COUNCIL ASSESSMENT PANEL

CAP Meeting Agenda

ITEM 4.1
DEVELOPMENT APPLICATION – 26000240 – 41 SHEFFIELD STREET, MALVERN

DEVELOPMENT NO.:	26000240
APPLICANT:	Rosa Retsas
ADDRESS:	41 SHEFFIELD ST MALVERN SA 5061
NATURE OF DEVELOPMENT:	Demolition of existing privacy screens and the construction of privacy screens attached to the existing southern and eastern boundary fences
ZONING INFORMATION:	**Zones:** • Established Neighbourhood **Overlays:** • Airport Building Heights (Regulated) • Co-located Housing • Historic Area • Prescribed Wells Area • Regulated and Significant Tree • Stormwater Management • Urban Tree Canopy **Technical Numeric Variations (TNVs):** • Maximum Building Height (Metres) (Maximum building height is 5.6m) • Minimum Frontage (Minimum frontage for a detached dwelling is 15m) • Minimum Site Area (Minimum site area for a detached dwelling is 750 sqm) • Maximum Building Height (Levels) (Maximum building height is 1 level) • Minimum Side Boundary Setback (Minimum side boundary setback is 1m for the first building level; 3m for any second building level or higher) • Site Coverage (Maximum site coverage is 50 per cent)

Figure 1 *– eastern boundary screen viewed from within the subject land*

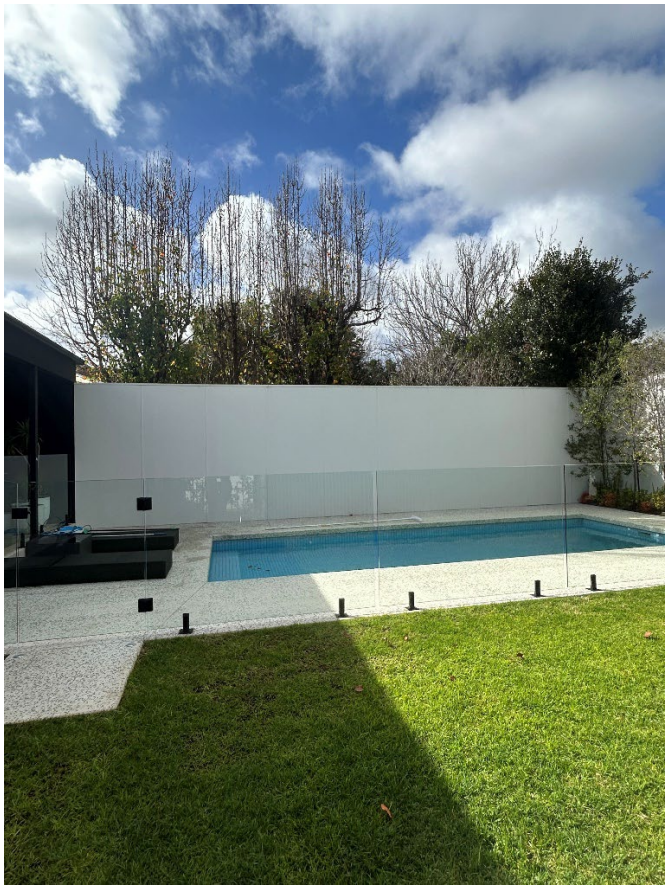
Two privacy screens constructed of fibre cement sheeting and attached to the existing boundary fencing via flashing. The screens will both have a height of 2.7 metres. The eastern screen is attached to the existing 2.1m boundary fencing and has a length of 12 metres. The southern screen is attached to the existing 2.4m boundary fencing and will have a length of 15.24 metres.

Whilst the application seeks retrospective approval, the length of the southern privacy screen has not been constructed in full.

ATTACHMENT 1

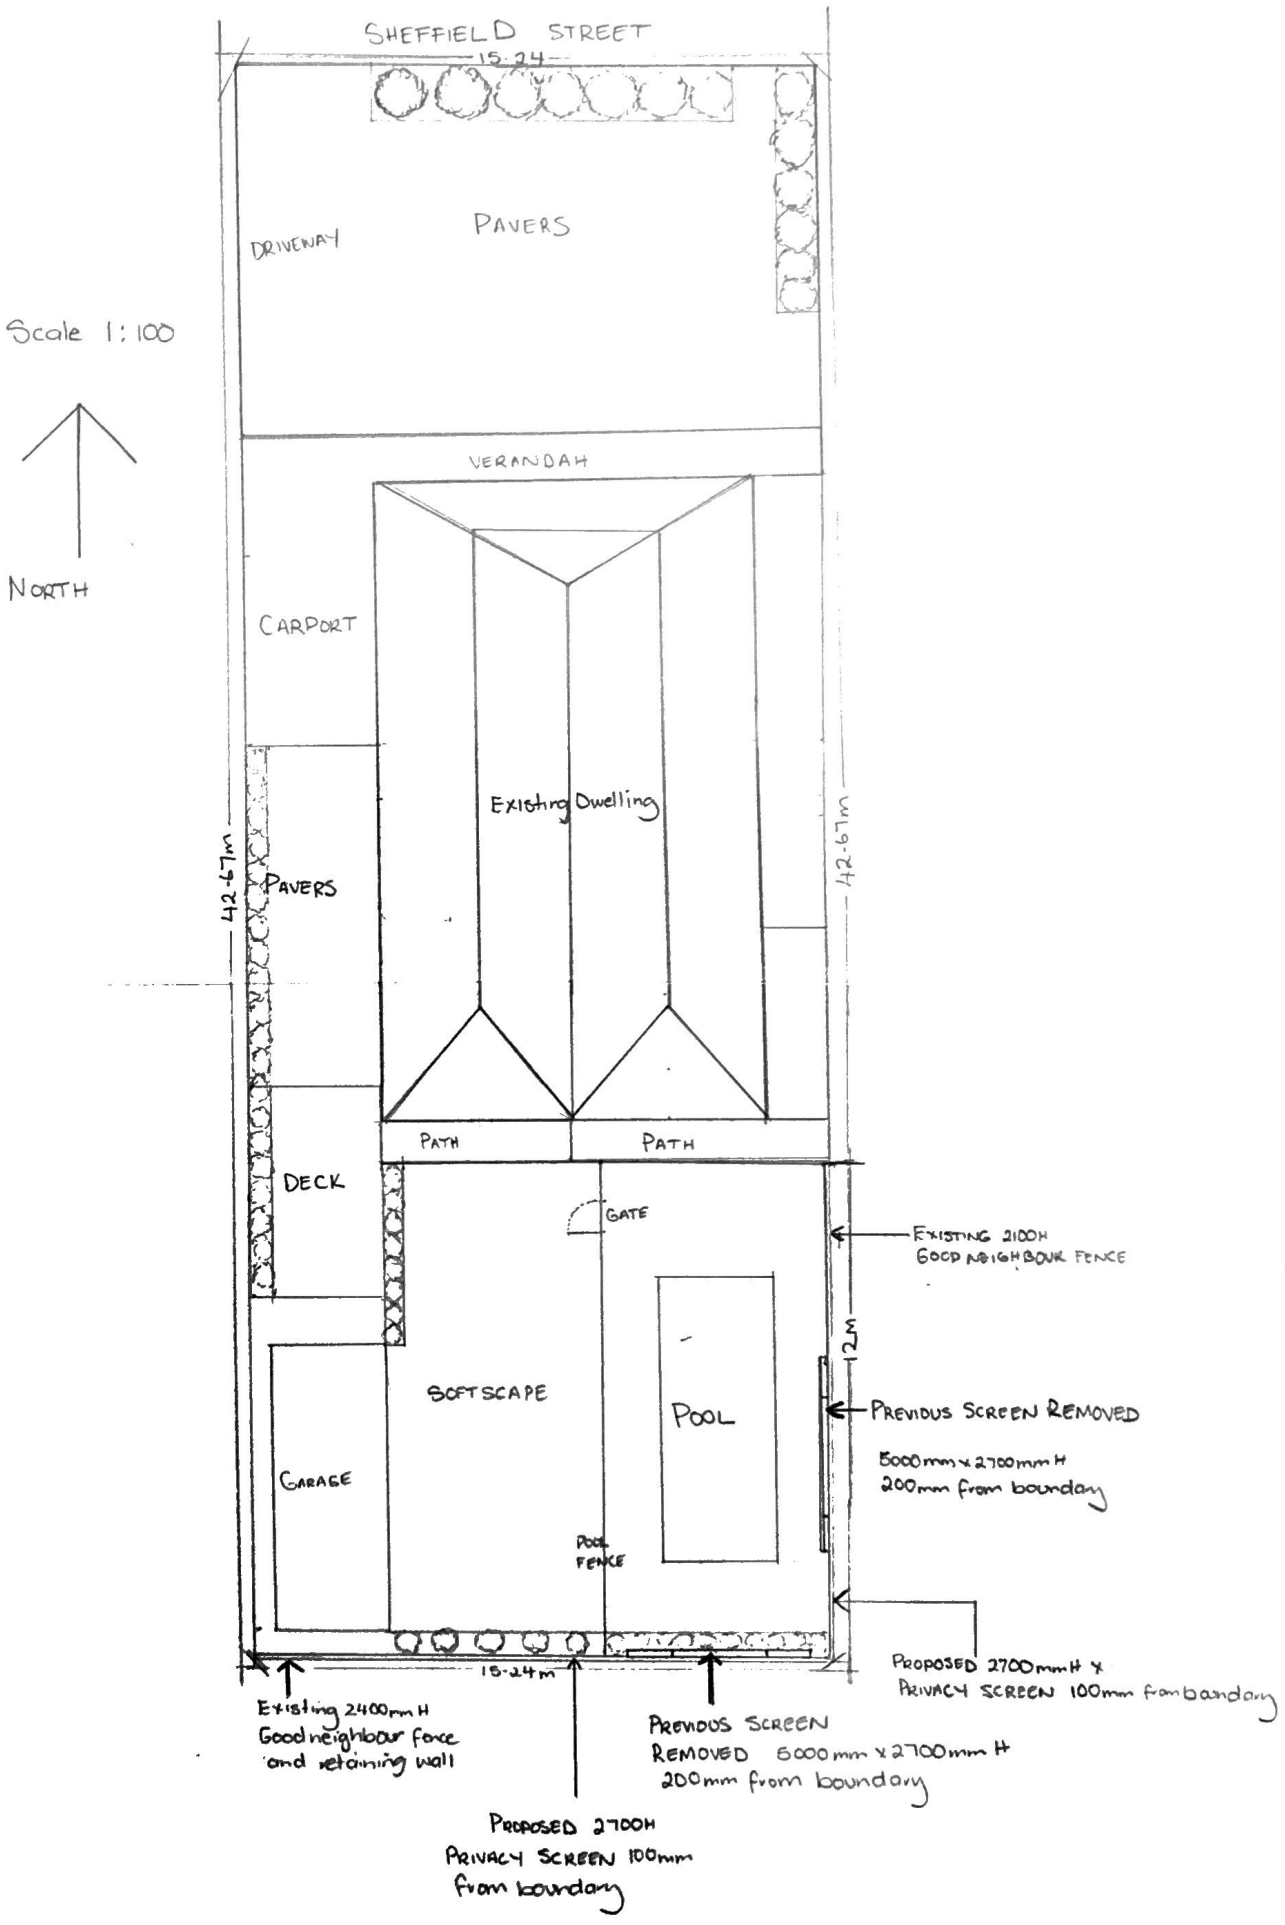
The plans show that the screen is to extend along the entirety of the southern boundary, at 15.24m. This is nearly double the length of the structure that currently exists on the boundary. While the effective height presentation to the southern boundary is less than that of the eastern boundary, the length of the southern screen as proposed is significant. This is inconsistent with **PO 7.1** of the **Established Neighbourhood Zone** which seeks boundary structures to be minimised in both height and length.

EAST ELEVATION

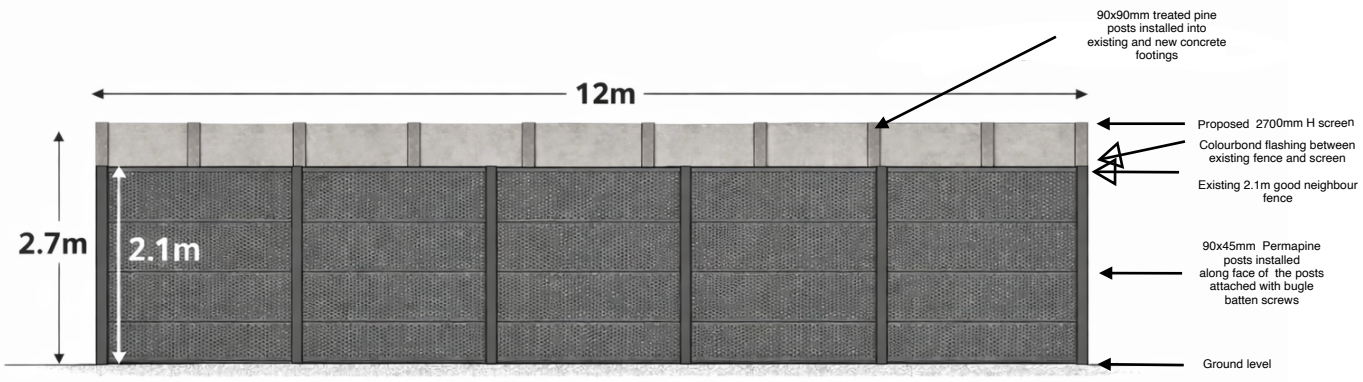
I submit that the additional screening sought along this property boundary is not necessary in the circumstance and would have a range of undesirable impacts with respect to solar access and visual amenity currently enjoyed by the [redacted] family. Accordingly, the application should be refused planning consent.

Our Objection: We consider the existing 2.1m good neighbour fence to provide adequate security and privacy. The addition of the proposed 2.7m screen is unnecessary from a noise reduction perspective and will not increase the noise dampening quality.

New 2700mm H non climbable, noise reducing, privacy screen in the pool area, constructed in front of existing east Colourbond boundary fence using 4.5mm Hardi flex cement sheeting painted in Dulux White Duck Quarter to the face and Dulux Classic Cream on the neighbours side

Drawing: SOUTH ELEVATION — SCREEN Scale: 1:100 @ A4	Site: 41 Sheffield Street, Malvern 5061

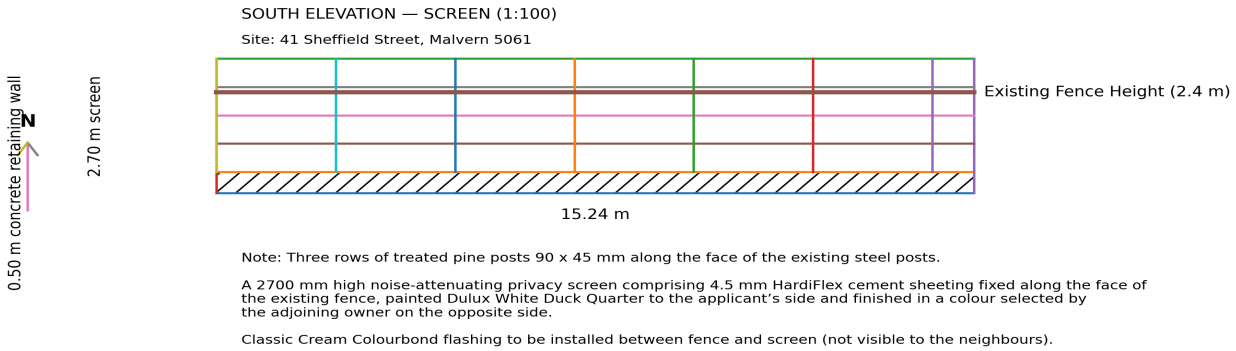
The existing boundary fence has a height of 2.6m when measured from the low side (a 2.1m high fence atop a 500mm concrete sleeper retaining wall). The proposal is to install a structure attached to this fence that would provide an additional 600mm of a solid material above, resulting in an overall height of 3.2m.

Colourbond flashing installed between the boundary fence and the new screen. Colour to match the existing fence in Classic Cream not visible from either side

The applicant has indicated a willingness to complete the flashing, rectify the workmanship concerns and provide a suitable neighbour-facing finish. We submit that these practical measures can appropriately address the construction and presentation concerns without requiring a reduction in screen height.

Figure 6. View along the pool barrier towards the southern screening.

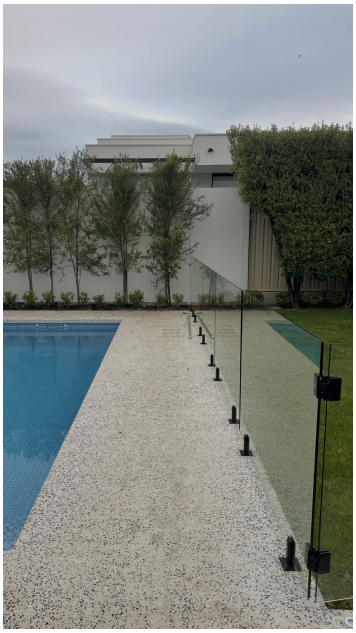
The applicant explains that a retaining-wall ledge of more than 100mm was exposed on the pool side when the southern fence was installed, creating a potential climbable foothold within the pool-barrier area. She states that advice was received from a Council officer during the pool renovation to provide sheeting or boarding to eliminate the hazard. This is a relevant functional explanation for screening at the affected portion of the boundary, although the precise pool-safety requirements and extent of necessary treatment would require confirmation through the relevant compliance process. *See Figure 6.*

***Figure 1-1** Comparison of ground floor plans*

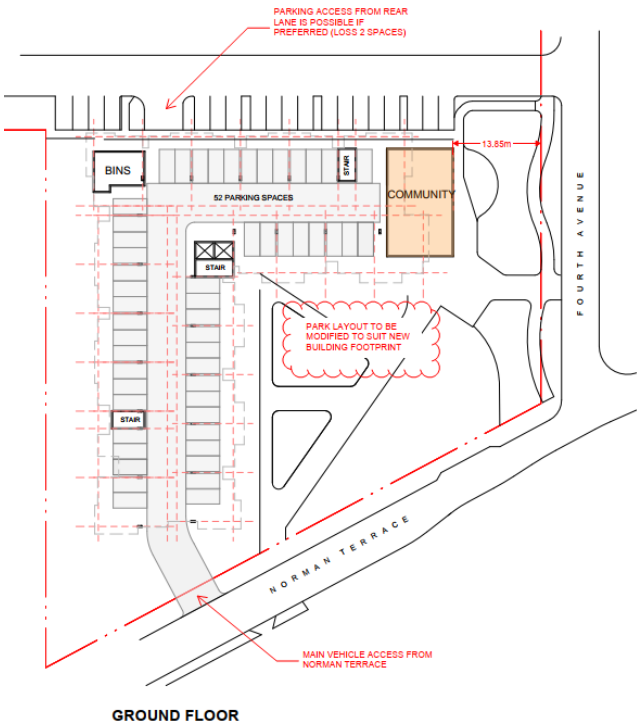
This variation application seeks to remove the basement carparking level and re-configure the at grade covered carparking spaces to 52 spaces (refer to **Figure 1.1** on the following page). This is achieved by:

Figure 1-1 Revised Plans showing dedicated resident bicycle parking in addition to visitor parking

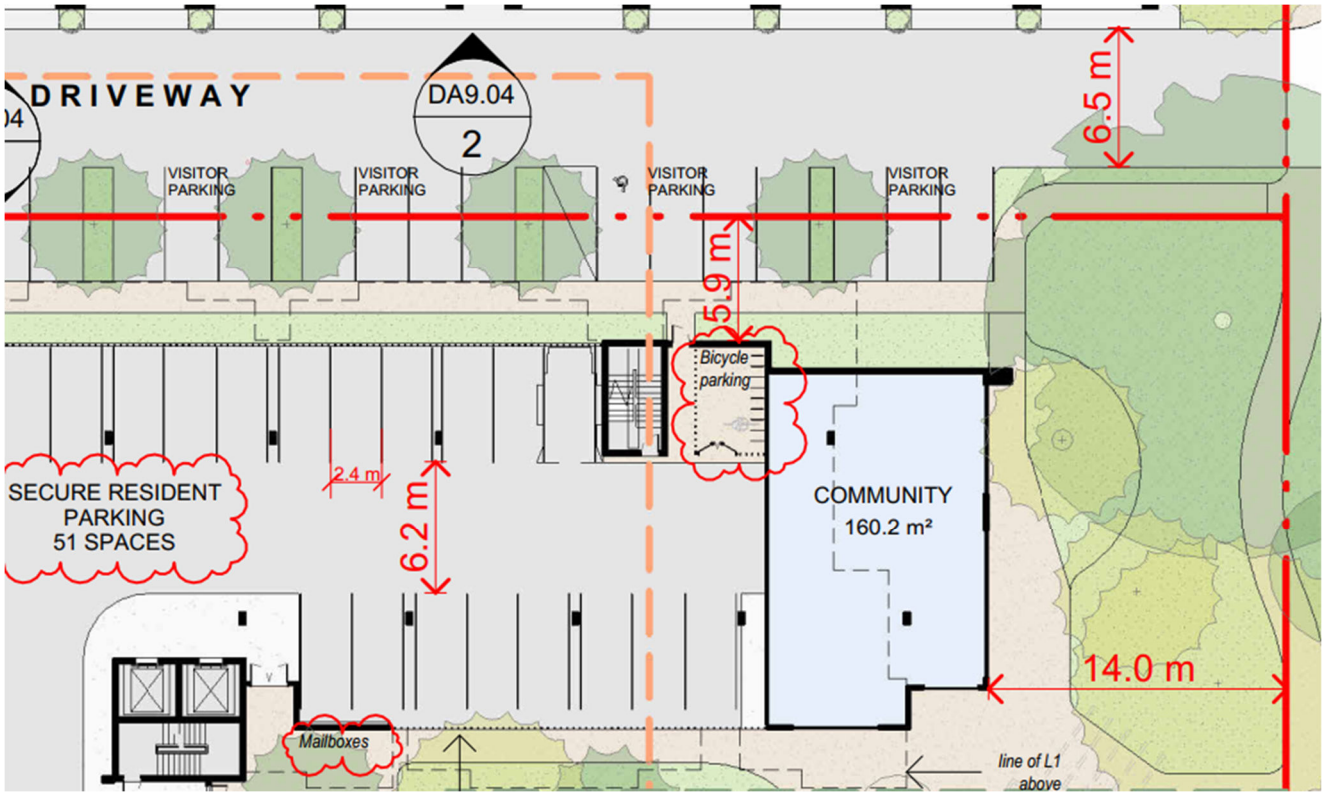
Council seek that additional bike parking spaces are provide that encourage active transportation options. Whilst it was recognised that the site is not located within a Designated Area, Council seek that the rate applied within *Table 3 – Off-Street Bicycle Parking* be provide d which equates to 19 resident spaces and 8 visitor spaces (27 in total).

The proposal has been updated to include a total of 14 bicycle racks, which will equate to a total of 28 spaces (refer to **Figure 1-1** and revised plans within **Appendix 1**).

As provided for, I seek the opportunity to appear before the Panel.

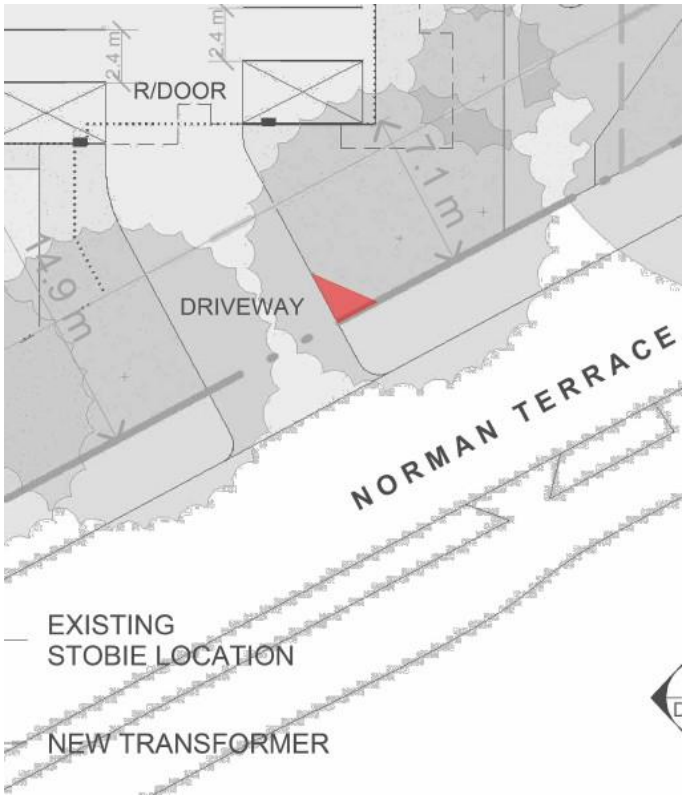
I also note that the land is subject to the Historic Area Overlay (Residential Spacious Unley & Malvern Trimmer Estate) which seeks contextually responsive development that is consistent with the prevailing historic characteristics of the area, which in my submission, does not include structures of nature proposed.

It is also informative to have regard to General Development Policies under the heading Design in Urban Areas including PO 9.1 which seeks *fences of sufficient height to maintain privacy without unreasonably impacting visual amenity and adjoining land's access to sunlight*.
